CONCEPTUAL DRAINAGE PLAN

EAST 1/2 OF LOT 2 AND ALL OF LOT 3, BLOCK 2, SIGMA CHI ADDITION
ALBUQUERQUE, NEW MEXICO

LOGAN/GROSS & ASSOCIATES, INC.
 CONSULTING CIVIL ENGINEERS
 925 6TH ST. N.W. SUITE 3 241-6353
 ALBUQUERQUE, NEW MEXICO 87102
 CONCEPTUAL DRAINAGE PLAN FILE # H-106
 FOR: PHILLIP BAIAMONTE DATE AUG. 1986
 AT: 1805 SIGMA CHI N.E. DRAWN CLL/CLB
 ALBUQUERQUE, NM SHEET 1 OF 1

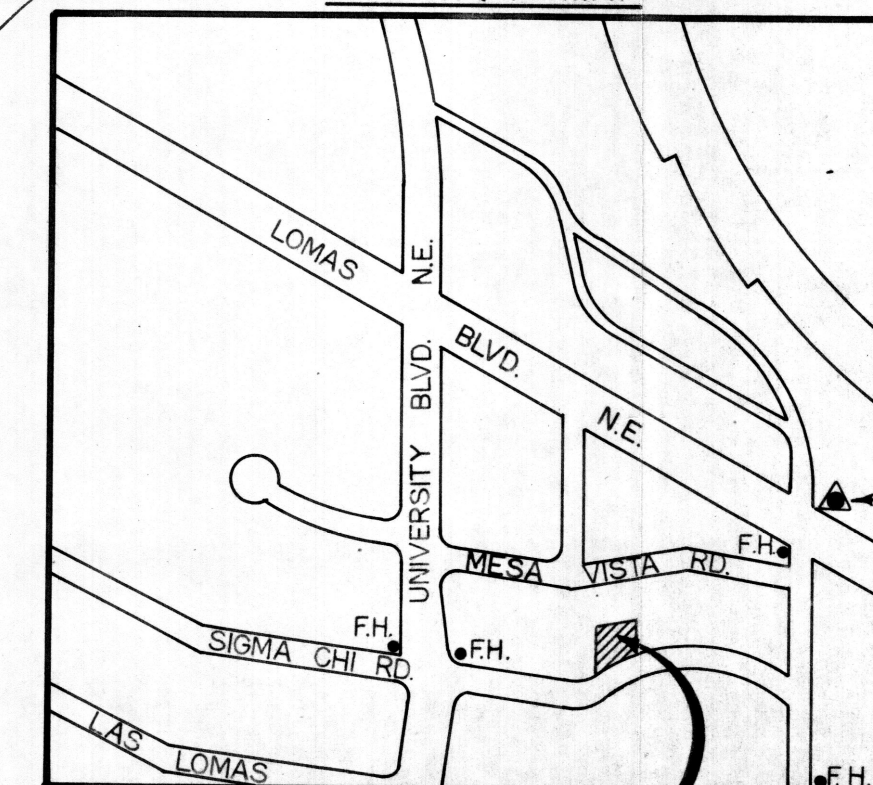
Pool Liner Required

on well a check side?
